**PUBLIC INTEREST REVIEW FOR GROUND WATER APPLICATIONS**

TO: Water Rights Section Date April 18, 2006  
 FROM: Ground Water/Hydrology Section Michael Zwart  
Reviewer's Name  
 SUBJECT: Application G- 16607 Supersedes review of N/A  
Date of Review(s)

**A. GENERAL INFORMATION:** Applicant's Name: David Duyck County: Wasco

G-16607  
WASC 2271

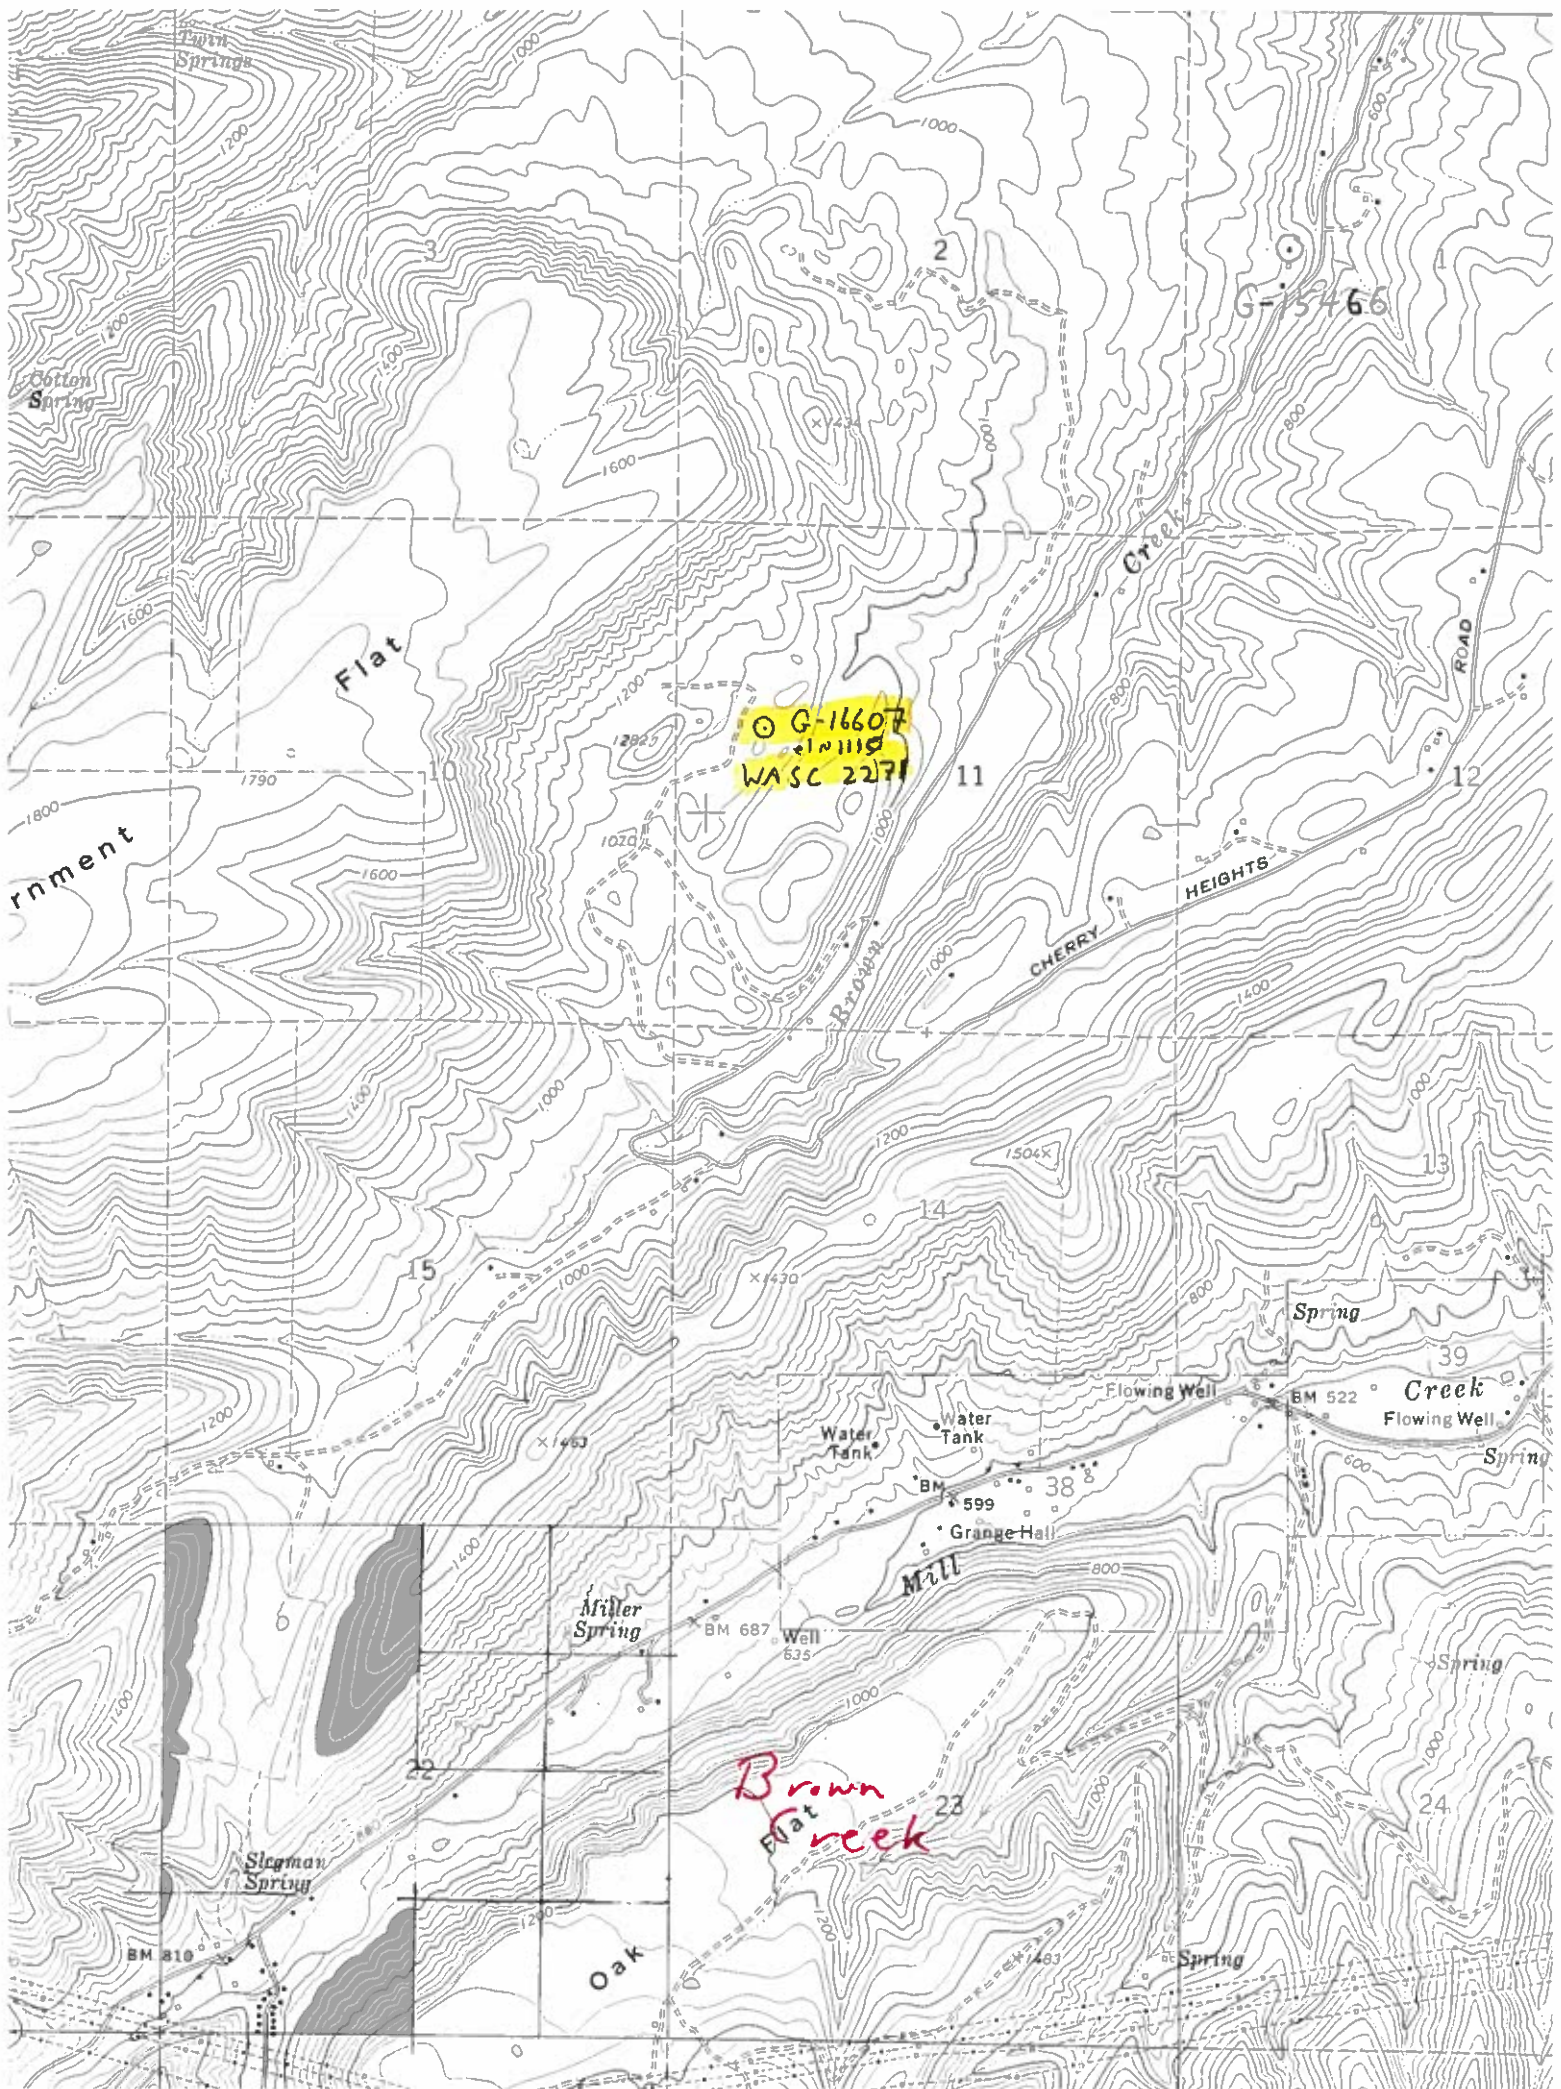
A4. **Comments:** Well develops Dalles Formation rocks. The well may not be able to produce the desired quantity, based on the air test.

Basis for aquifer hydraulic connection evaluation: The regional ground-water flow direction suggests better hydraulic connection with Chenoweth Creek, where several springs are mapped in the Dalles Formation rocks. The generally low transmissivity of this aquifer indicates that the impacts will likely be very localized.

**Basis for impact evaluation: I believe that the Hunt/Wozniak models are not appropriate for calculation of potential interference. The Dalles Formation includes numerous semi-isolated water-bearing zones and most are not laterally extensive. Watermaster staff report that Brown Creek is effectively dry except during spring runoff.**
